EVALUATION REPORT REPORT 1029 3 FEBRUARY 1961

NEL/Report 1029

Engineering Tests of the AN/PQS-1 Hand-Held Sonar,

Figure 1. The carrying case.

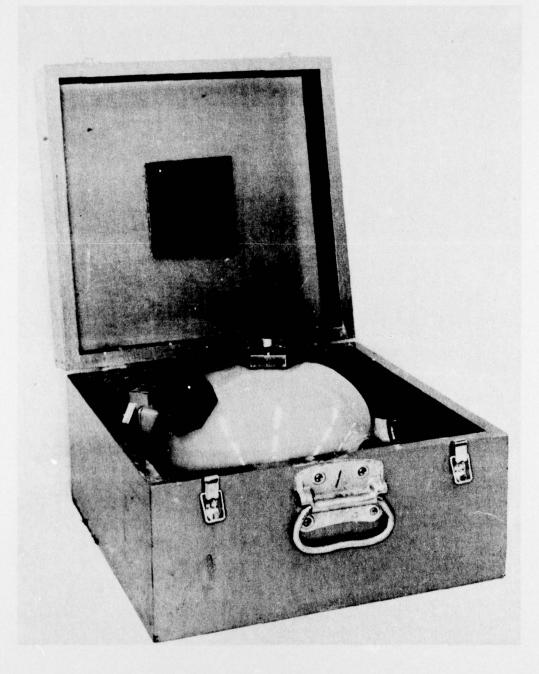
9. Metal reinforcing should be placed on the outside eight

corners of the wooden carrying case (fig. 1).

10. The inside rubber padding of the wooden carrying case does not adequately support the sonar. Thicker and harder rubber is recommended, especially under the raised edges of the welded grill guards of the sonar.
